Project Name: Park Boulevard Extension
Project Number: IFB No. 2024-458
Subject: Change Order #003

Halff recommends the following change order #003 modification to the Park Boulevard Extension project.

PARK BOULEVARD EXTENSION

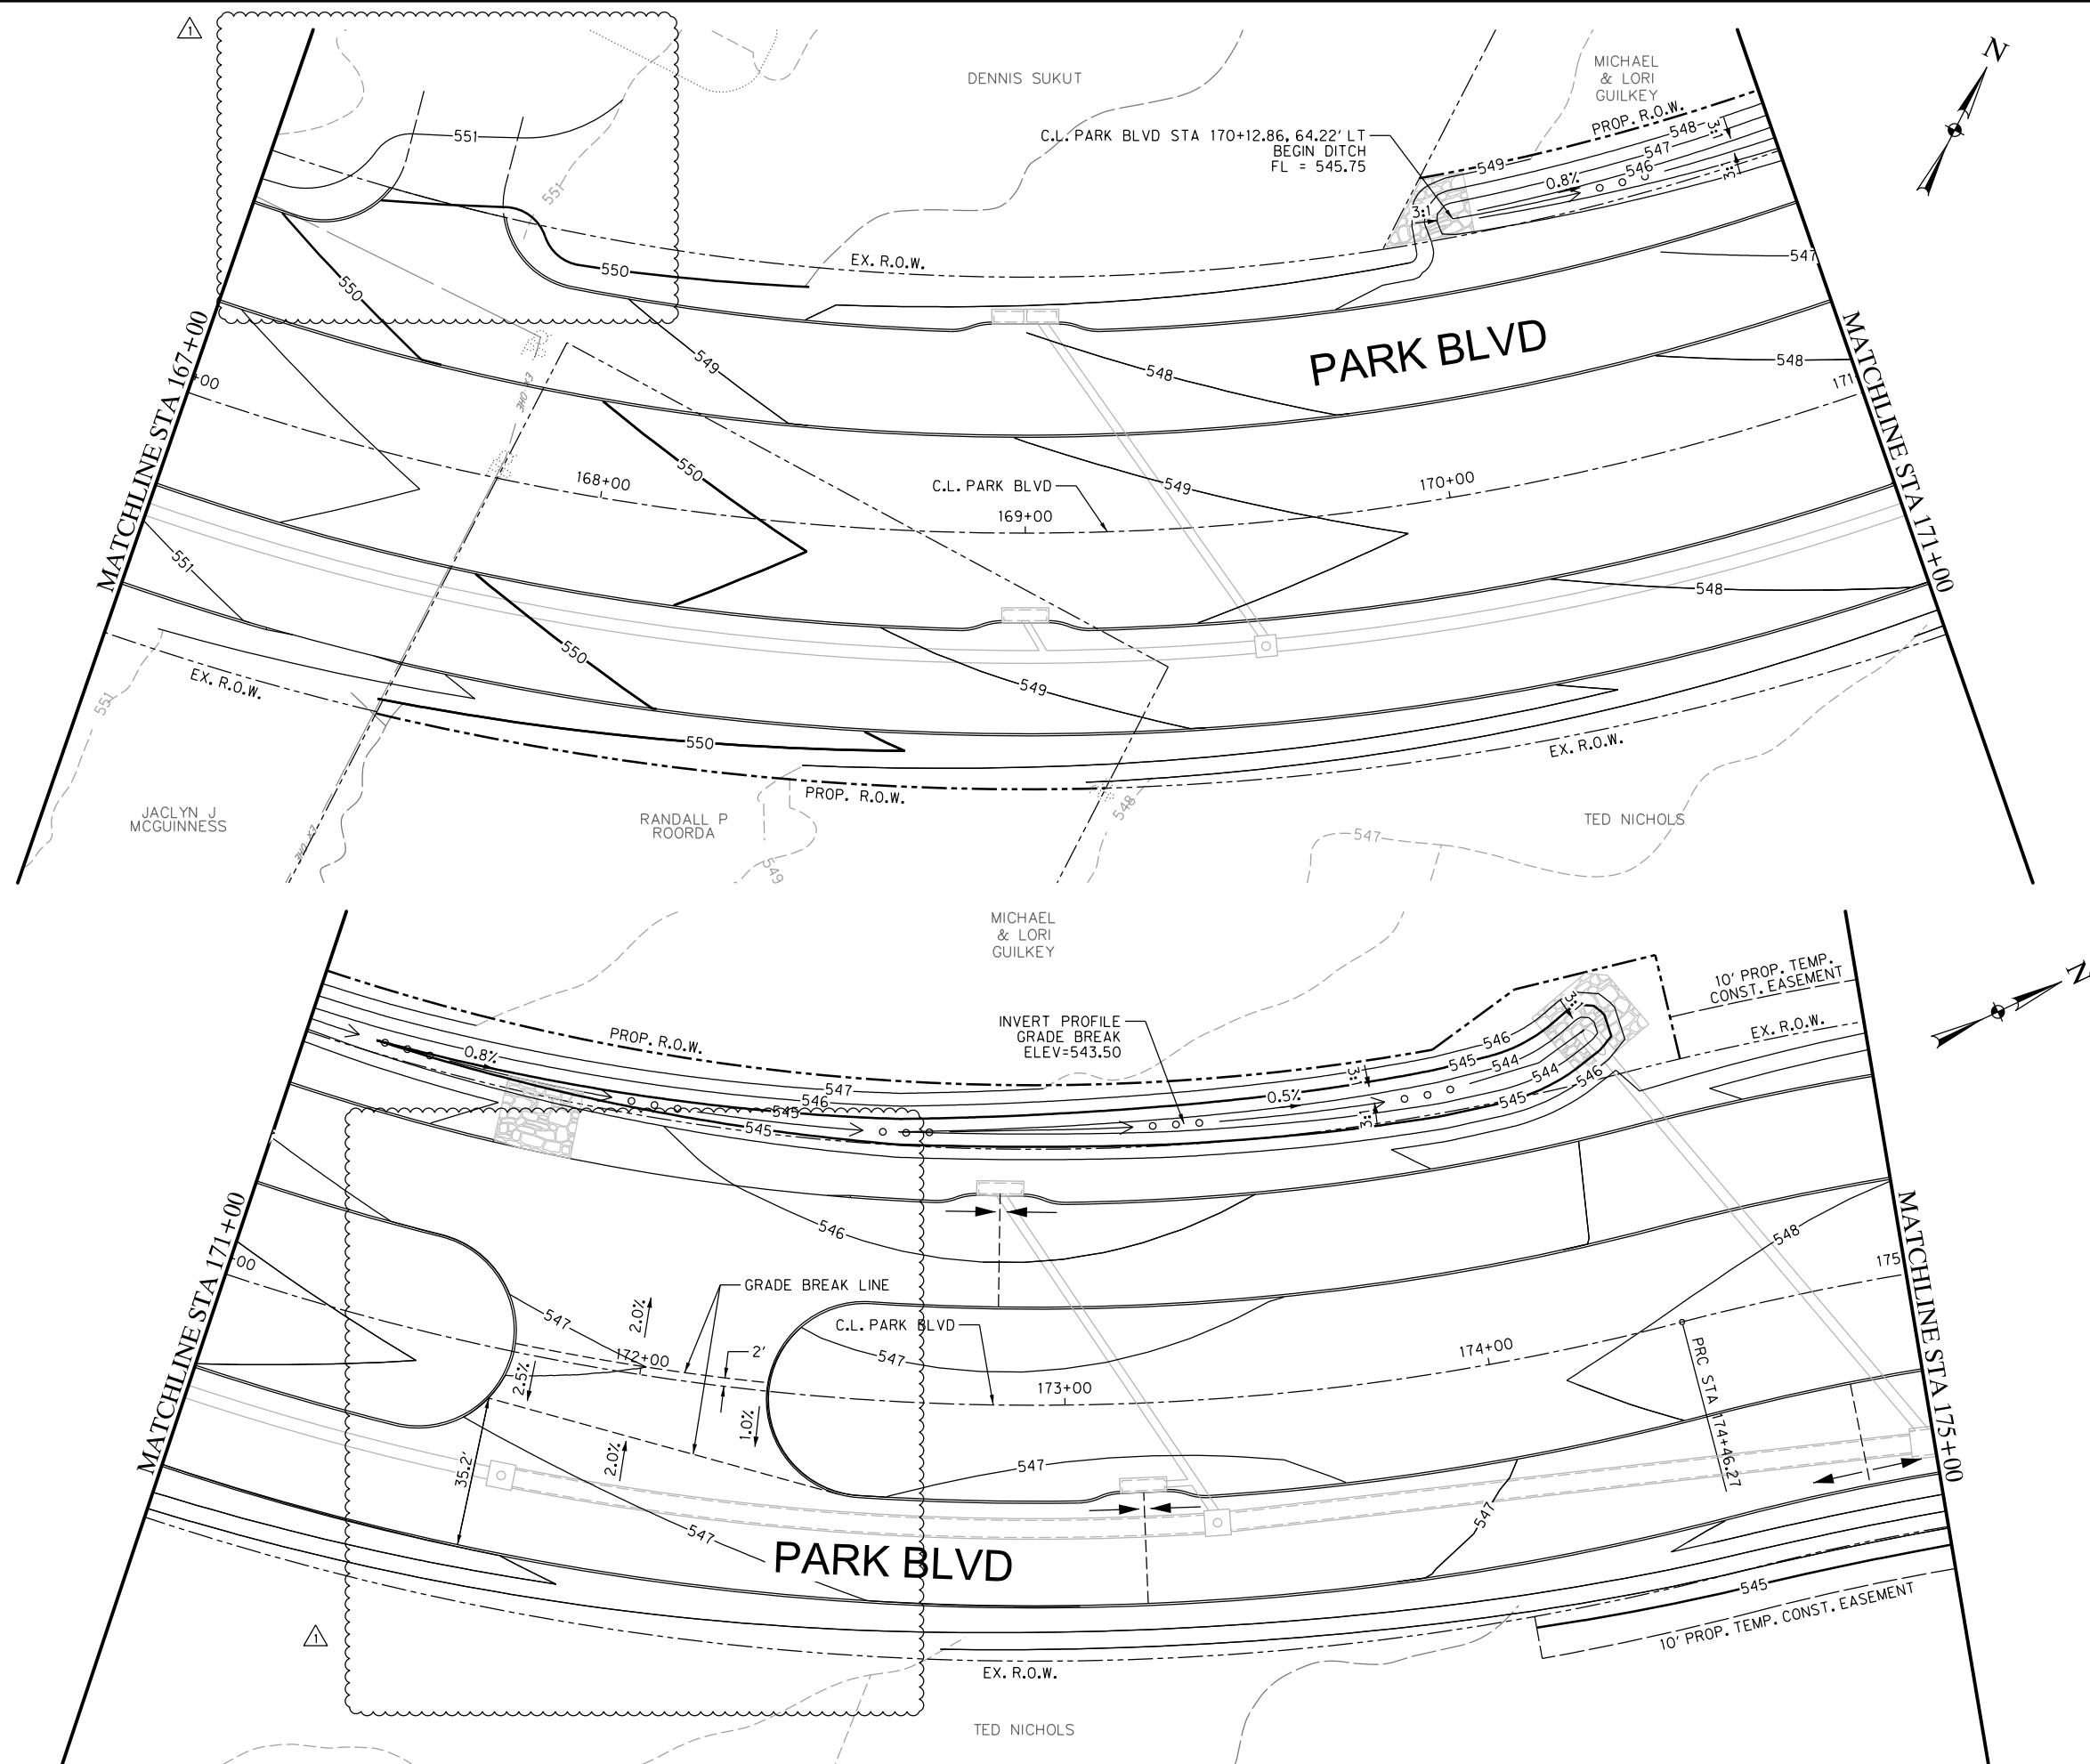
1	04/22/2026	SUKUT DRIVEWAY & MEDIAN OPENING	AK
No.	DATE	REVISION	APPROV.
PARK BOULEVARD EXTENSION

GRADING PLAN STA 183+00 TO STA 192+00

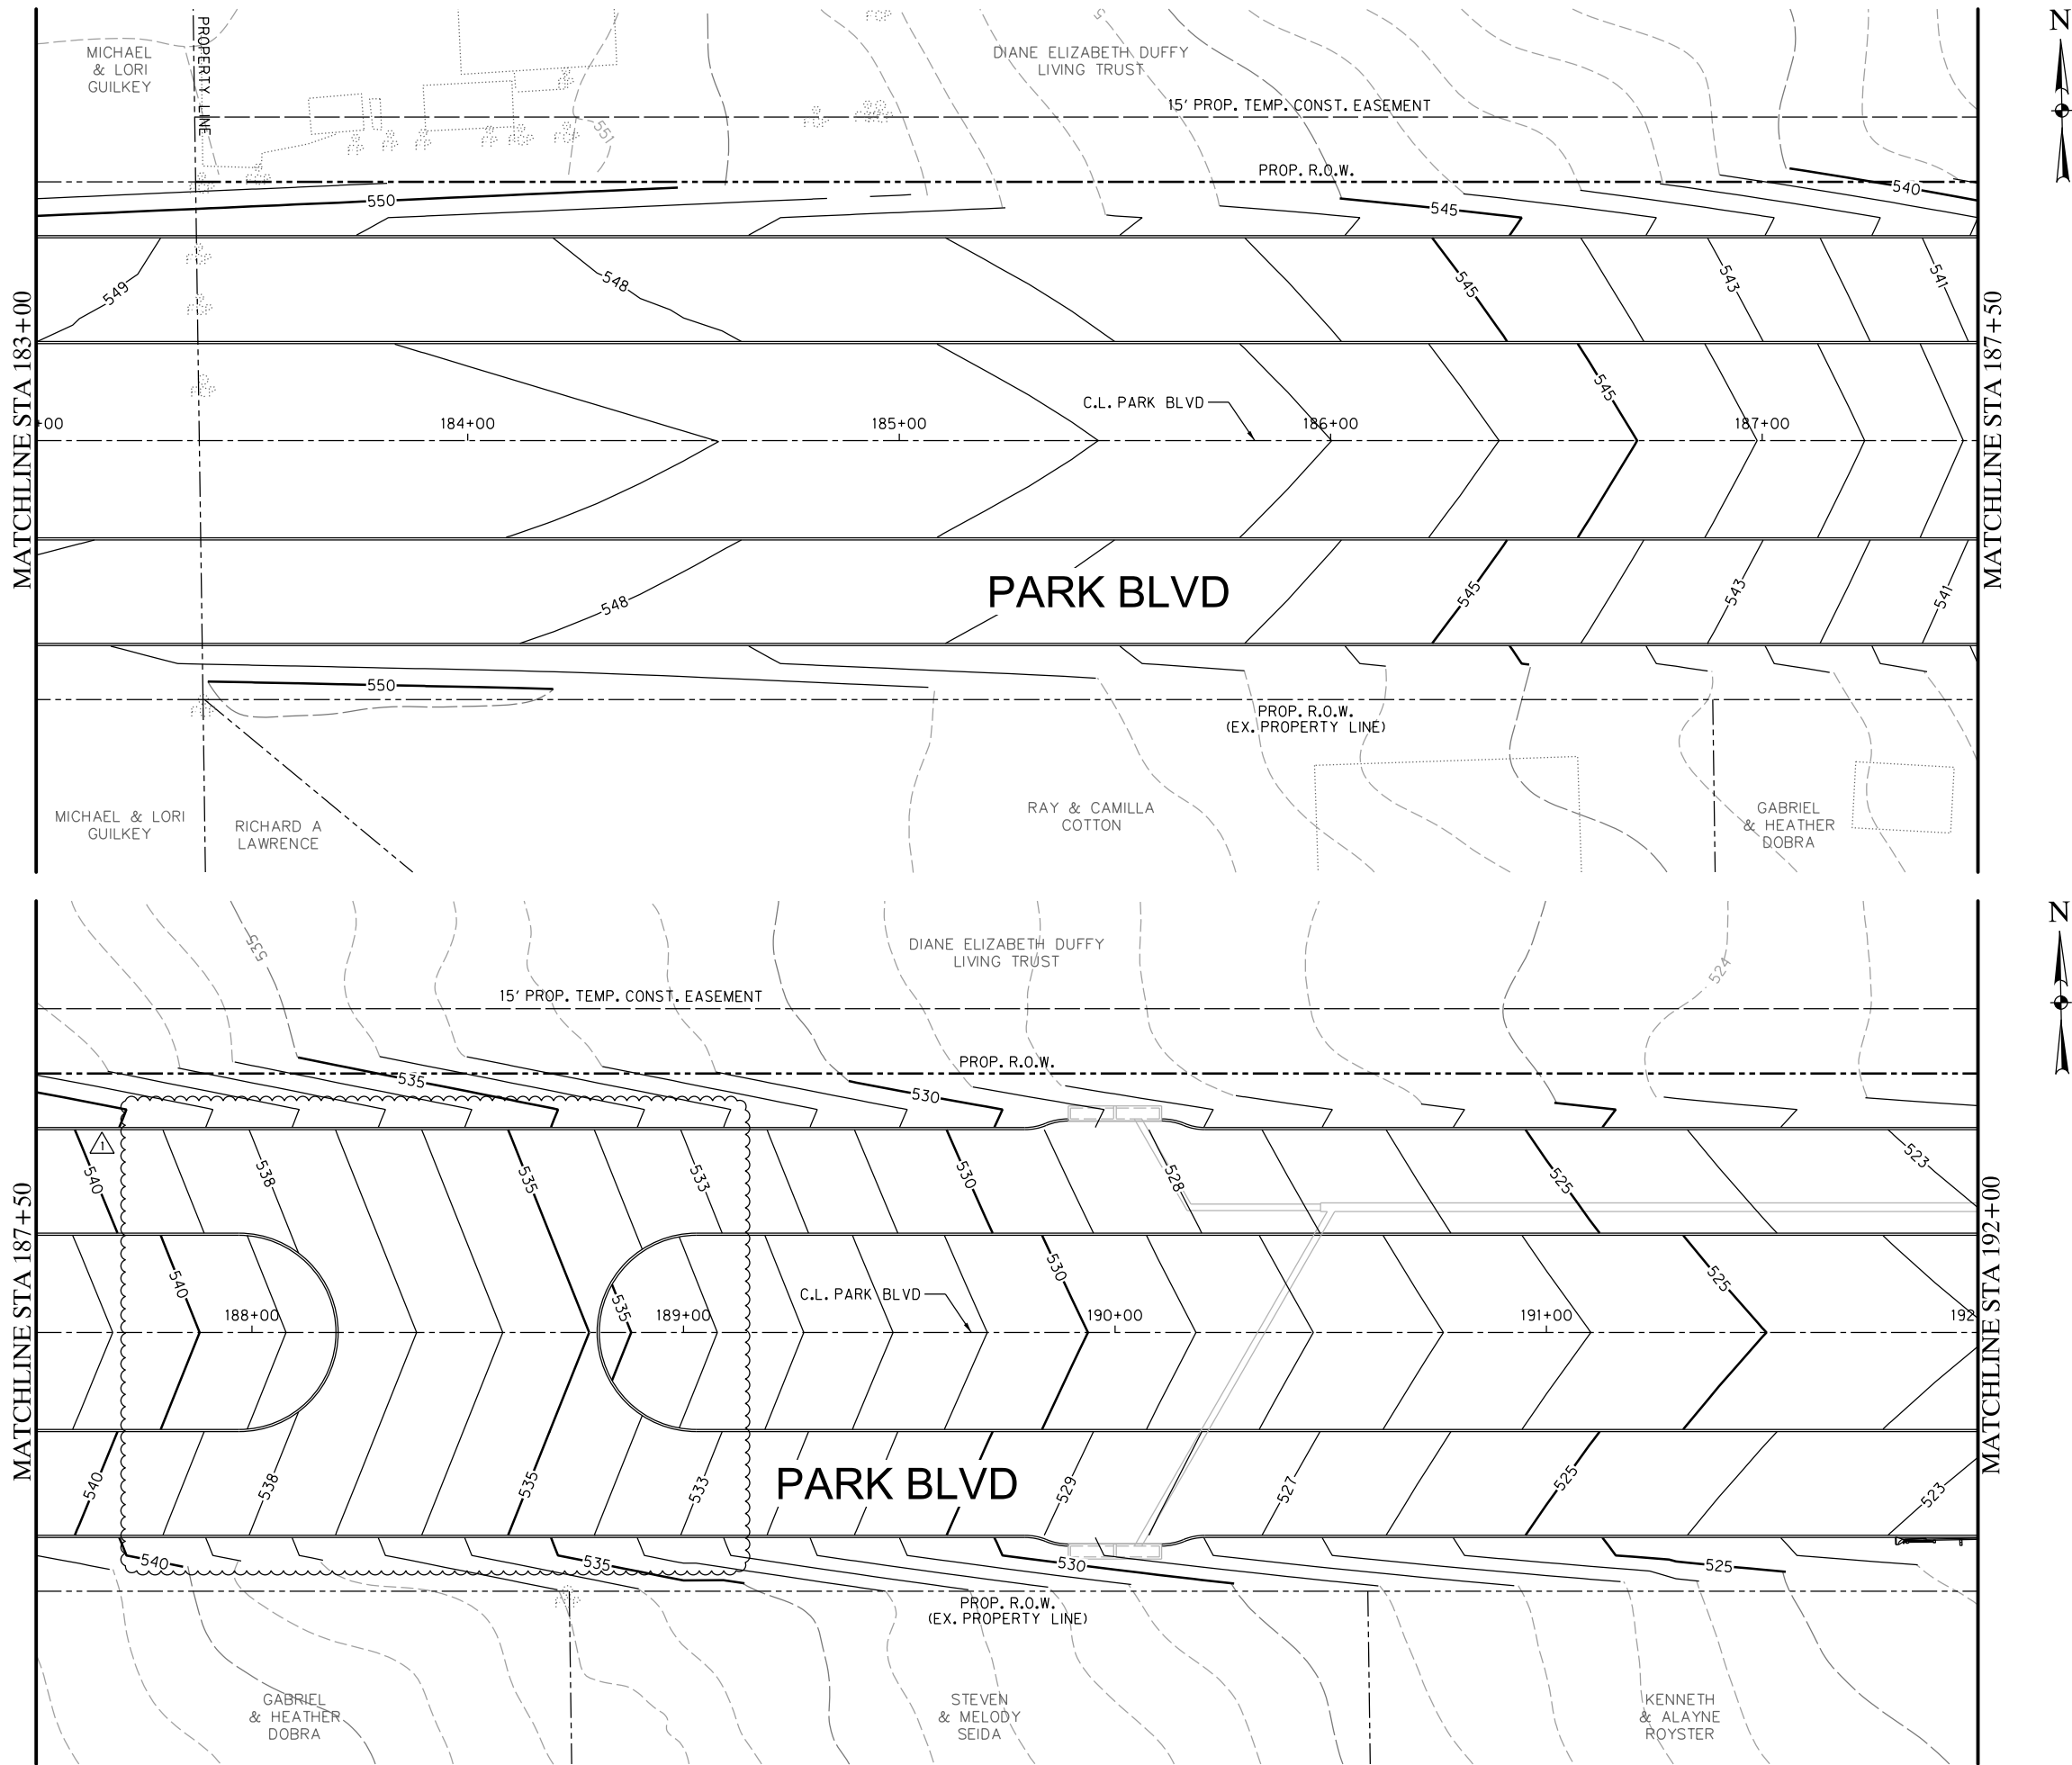
1	04/22/2026	MEDIAN OPENING	AK
No.	DATE	REVISION	APPROV.
PARK BOULEVARD EXTENSION

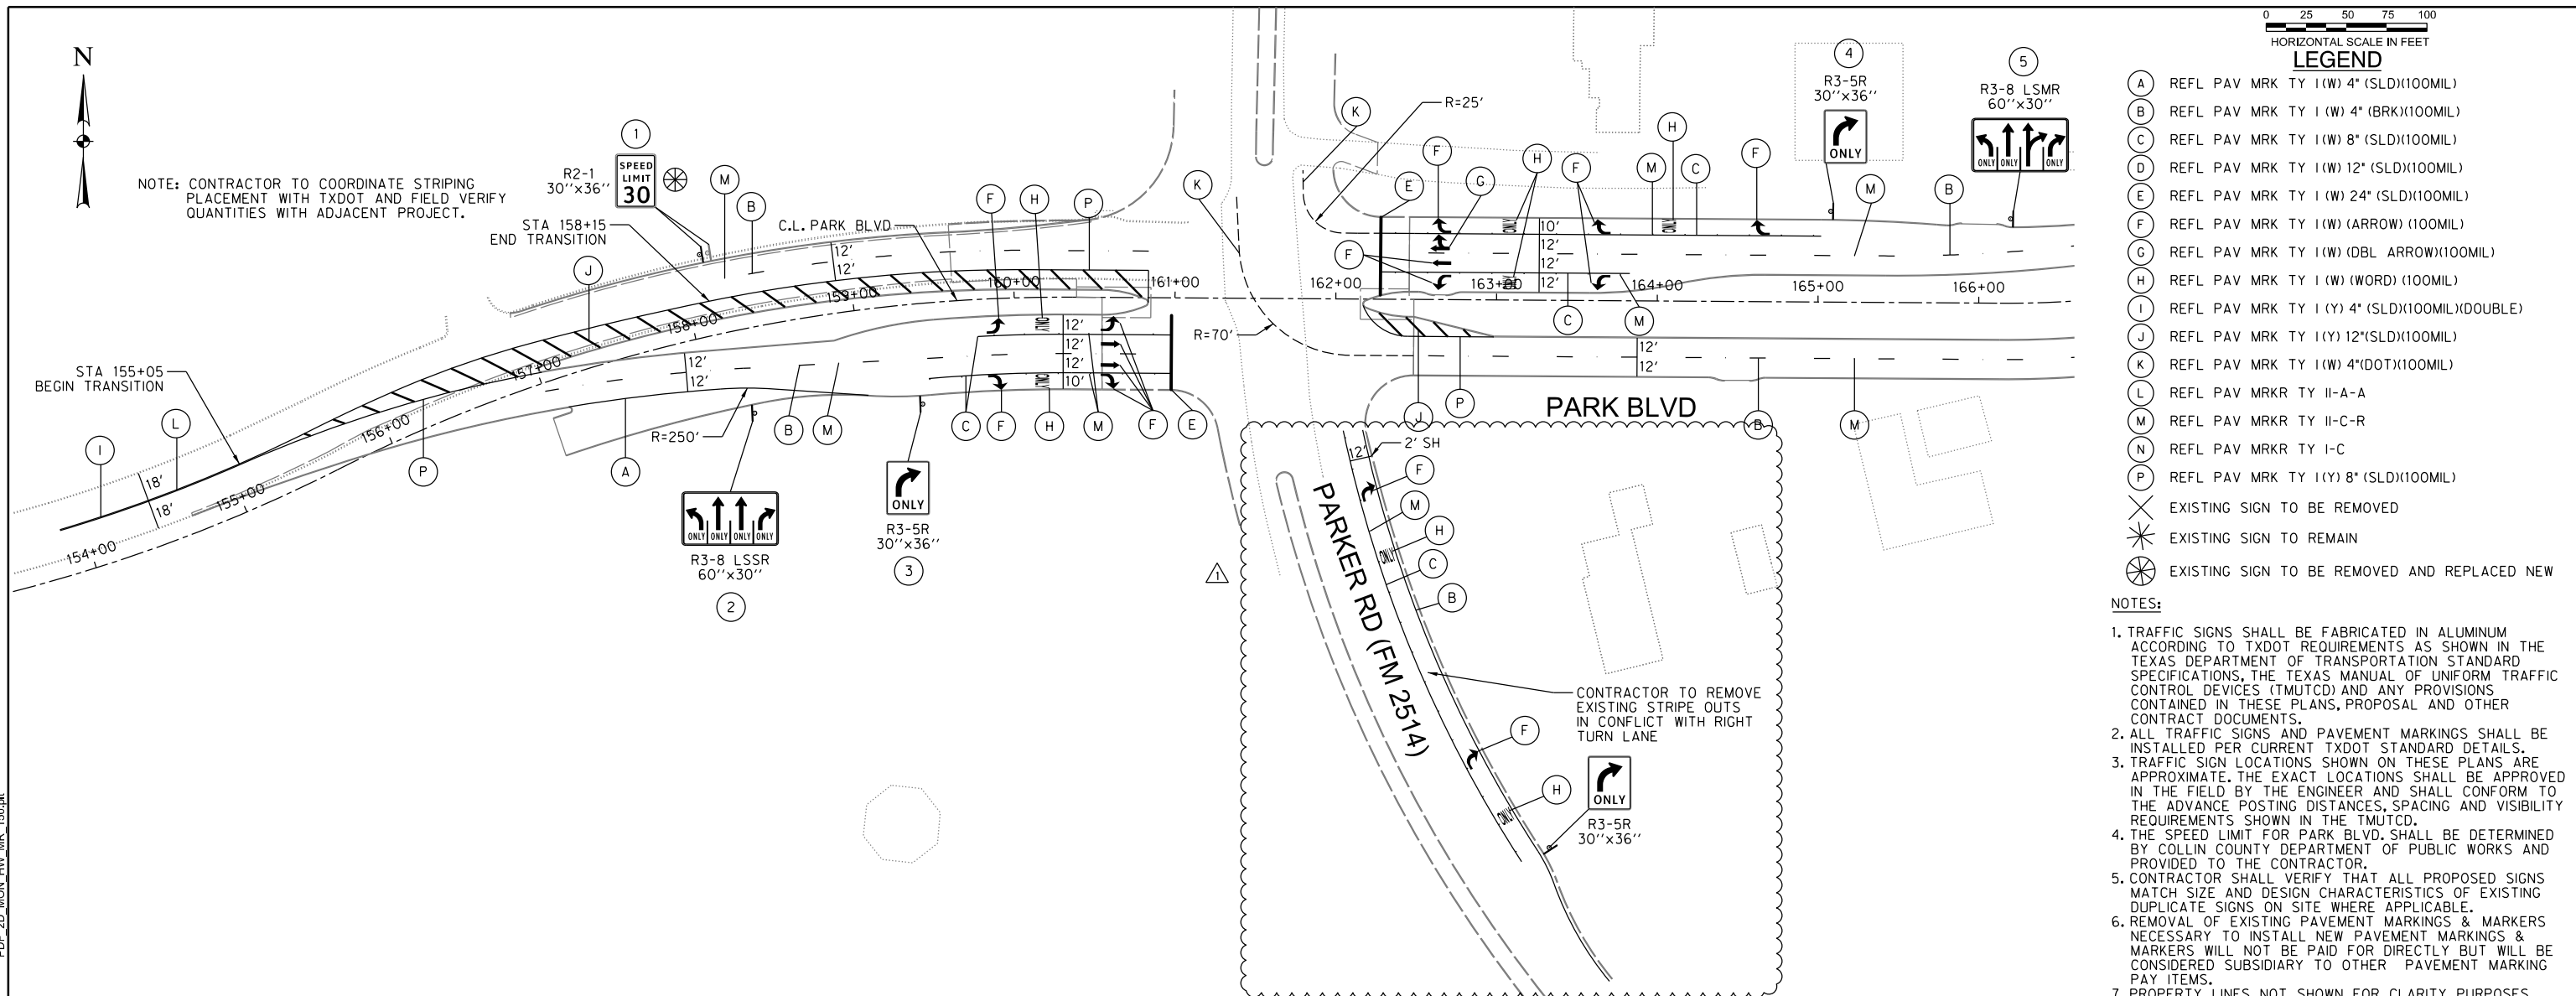
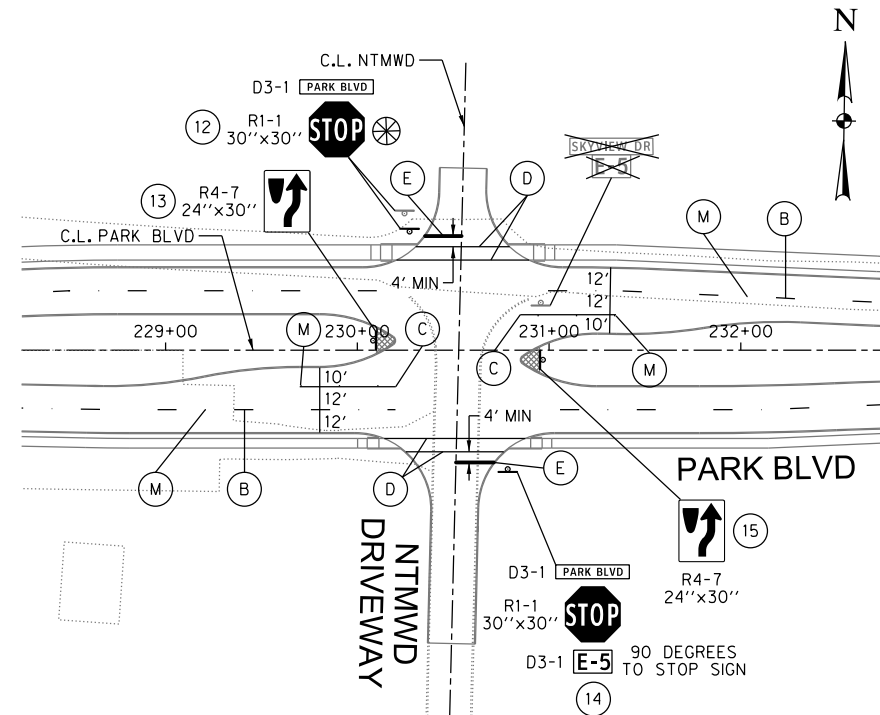
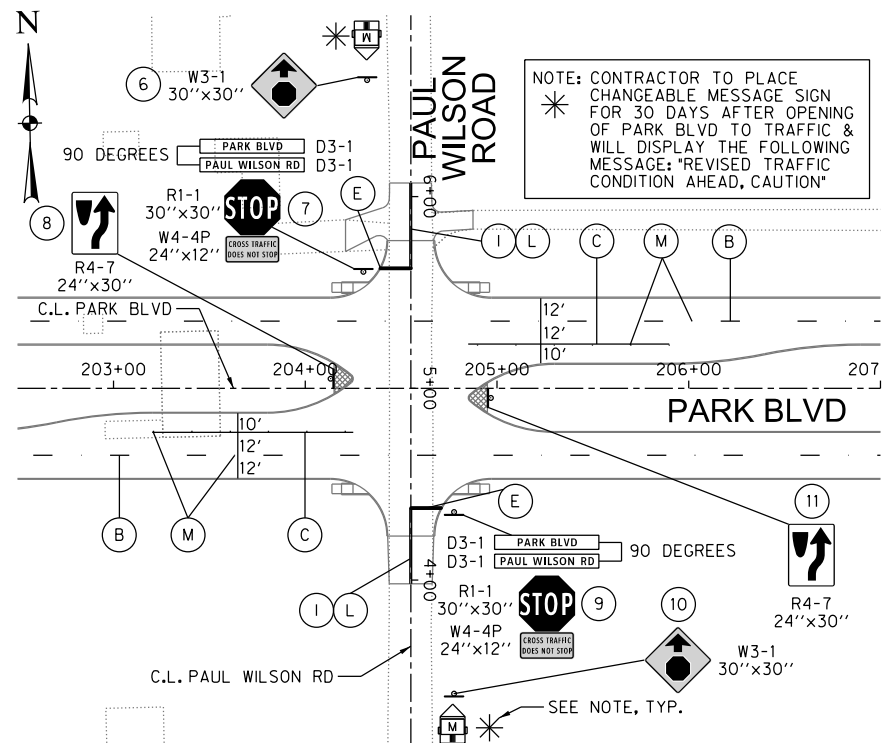
03-10 – REFL PAV MRK TY I (W) 4" (SLD)(100 MIL) – This is a plan quantity adjustment for striping revisions for the right turn lane (NB-EB) at the Parker Road and Park Boulevard intersection.

03-11 – REFL PAV MRK TY I (W) 8" (SLD)(100 MIL) – This is a plan quantity adjustment for striping revisions for the right turn lane (NB-EB) at the Parker Road and Park Boulevard intersection.

1	06/19/2026	NB-EB RIGHT TURN LANE SIGNING AND STRIPING	AK
No.	DATE	REVISION	APPROV.
PARK BOULEVARD EXTENSION			
SIGNING AND STRIPING PLAN			
3803 PARKWOOD BLVD, SUITE 800 FRISCO, TX 75034-8641 TEL (214) 618-4570 FAX (214) 739-0095 TBPELS FIRM #F-312			
DRAWN: PTS	DATE: 10/25/2024	DESIGNED: AK	DATE: 10/25/2024
CHECKED: TMW	DATE: 10/25/2024	SCALE: 1"=100'	
CONTRACT No. 35192			
SHEET 307	OF 502	SST-05
